CREAK/SQUEAK NOISE FROM REAR SUSPENSION

Bulletin No: 02-002/01

Last Issued: 02/28/2000

All 1995-2000 Millenia.

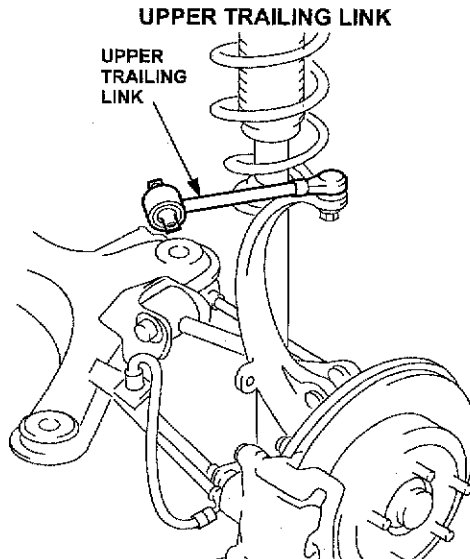
When driving at slow speeds, entering driveways, driving over speed bumps in parking lots, or driving on rough roads, a creak or squeak noise may be heard from the rear suspension. This noise may be caused from lack of lubrication at the ball joint area of the upper trailing link(s). The noise may also be heard by pushing down on the rear of the vehicle when stopped. An improved part with an increased diameter ball joint and improved lubricant is available to resolve this concern.

- If noise is not present, replace both upper trailing links with the modified part.

UNDERBODY MOUNTING AREA FOR TRAILING LINK

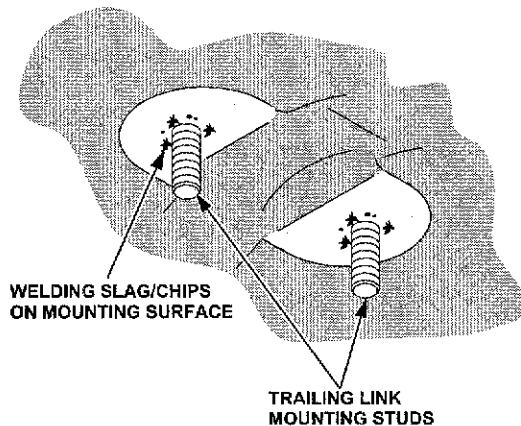
NOTE: Before installing new links, check the base of each mounting stud (body side) for excess weld slag/chips. If found, remove them with hammer and chisel.
